SUBDIVISION REVISION – FINAL PLAT

<p>Owner: Bernard A. Giroux Trust, June T. Giroux Trust, Victor J. Giroux Trust and Ramona M. Giroux Trust. They own both lots</p>	<p>Applicant: Tyler Sterling for Hannaford Bros. Co.</p>
<p>Surveyor/Engineer: O’Leary Burke Civil Associates 1 Corporate Drive Essex Jct. Vt.</p>	<p>Property Tax Parcel: 20-50-02.200 and 20-50-74.000</p>

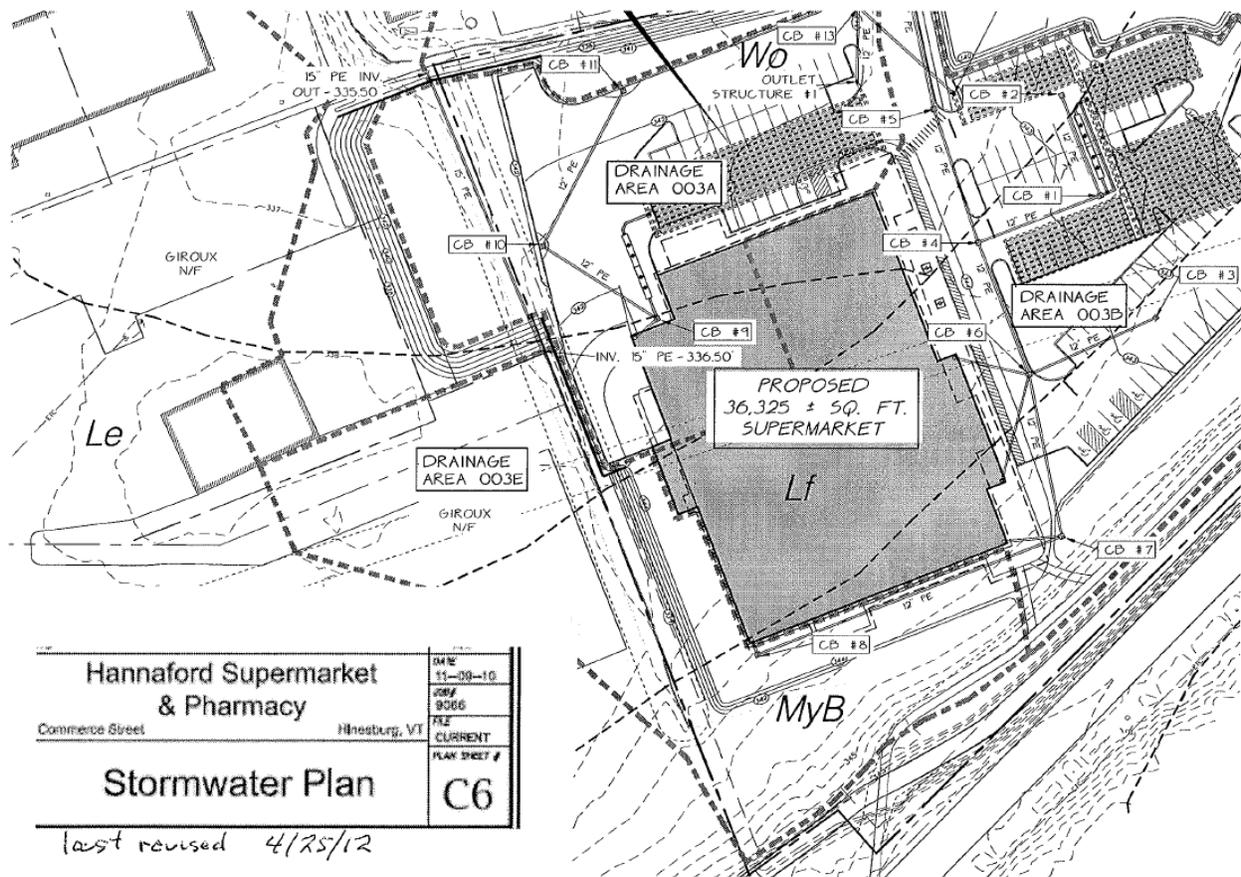
The proposed new parking area in the north eastern portion of the driveway appears to drain directly into that swale around the northern end of the proposed raised platform on lot 15 with no stormwater treatment proposed.

The swale which is proposed to be eliminated also accepts in indeterminate amount of stormwater from the Giroux storage yard lot, where it is treated and slowed down. No evidence has been presented about the impact of the elimination of this portion of the swale. It also collects the water from the south western corner of lot # 15.

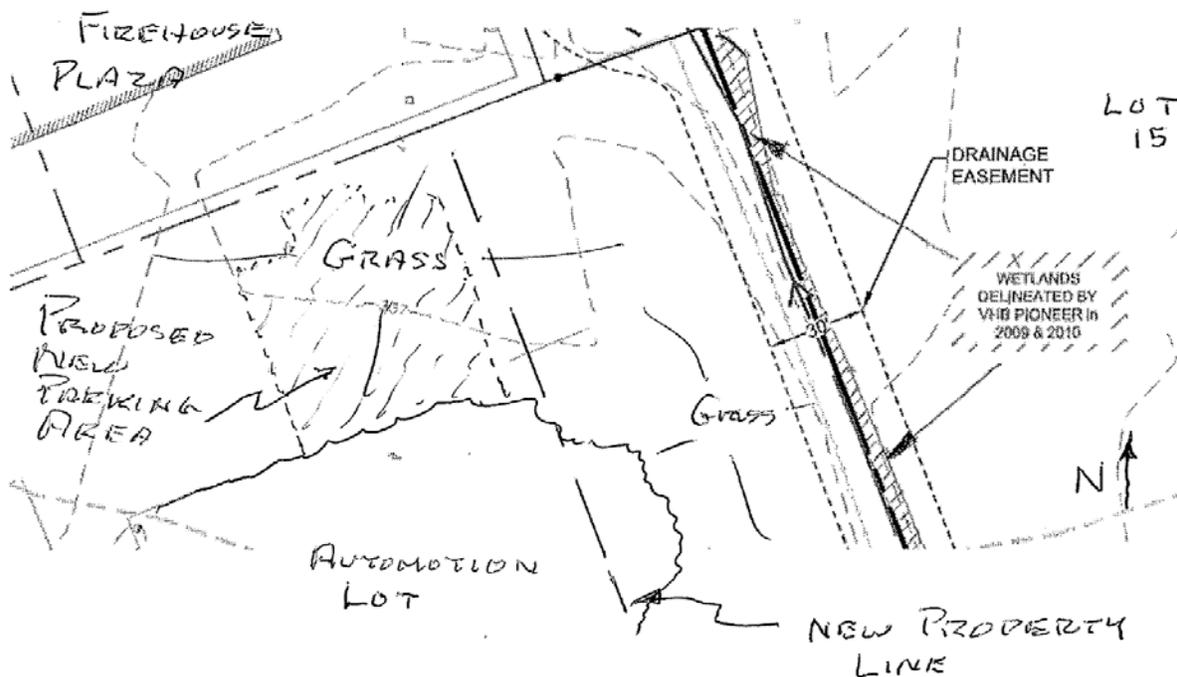
Wetlands have been identified for lot #15 (refer to the plan below) up to the boundary and they continue to an unknown extent onto the area to be transferred and covered by fill. The Planning

Standards, Section 5.1.2 Natural Features Protection – requires due regard to, among other issues, wetlands and until they have been identified a finding of due regard is impossible.
